UNITED STATES PATENT AND TRADEMARK OFFICE

APPLICATION NO.	FILING DATE	FIRST NAMED INVENTOR	ATTORNEY DOCKET NO.	CONFIRMATION NO.
10/531,441	11/15/2005	Thomas Froehlich	FROH3003 /FJD	6201
23364 7590 12/17/2007 BACON & THOMAS, PLLC 625 SLATERS LANE FOURTH FLOOR ALEXANDRIA, VA 22314			EXAMINER PATEL, HARSHAD R	
			ART UNIT 2855	PAPER NUMBER
			MAIL DATE 12/17/2007	DELIVERY MODE PAPER

Office Action Summary	Application No.		Applicant(s)	
	10/531,441		FROEHLICH ET AL.	
	Examiner		Art Unit	
	Harshad Patel		2855

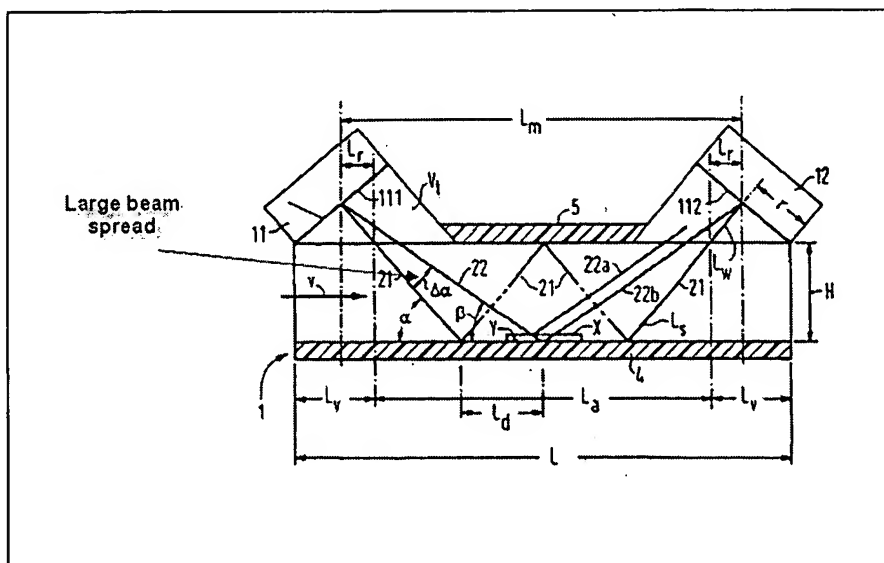
Russwurm teaches the device as claimed including an inherent and essential element, the control or evaluation unit. Russwurm does not explicitly describe the control unit, but such an element would be an inherent element in order to

process the measured signals. Fig. 1 shows an entire structure of the instant invention including the beam spread as labeled inhere and thus the claims as claimed considered anticipated since such a structure would inherently have a large opening for the waves to be transmitted as shown in Fig. 1 to form a "V" or a "W" shape. A minimum separation between the two transducers is represented by distance " L_m ". Russwurm does not teach the uses of a specific process parameter including, however, Su teaches the use of determining the inner diameter of the pipe in the computation of flow rate. It would be obvious to a person having ordinary skill in the art at the time the invention was made to use the determined inner diameter in the computation of the flow volume since such a value would provide better and reliable measurement results.
